Re: Quality Assurance Project Plan for the Phase I Risk Assessment, Rev. 0; Lincoln Park Superfund Site OU1/OU2/OU3 Canon City, Fremont County, Colorado EPA ID No. COD042167858

**Attachment 1:**  
**EPA and CDPHE Quality Assurance Project  
Plan Technical Review Crosswalk**

## Combined Agency Comments on Phase I Risk Assessment UFP-QAPP

## OU2 (Lincoln Park) Irrigated Soil Investigation

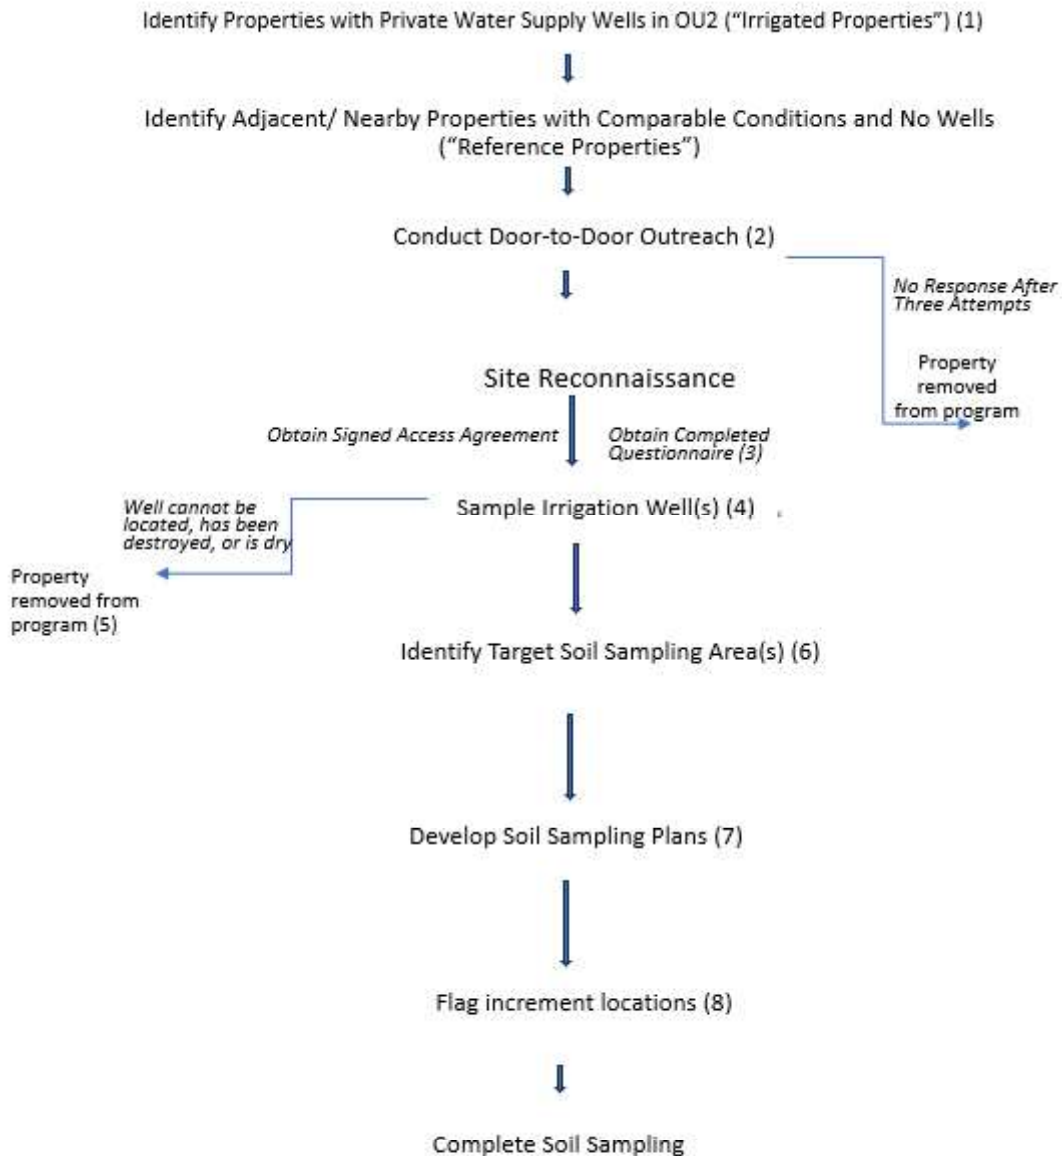
**Question 1:** Does the EPA agree with this procedure - and the accompanying forms - to identify irrigation-impacted soils?
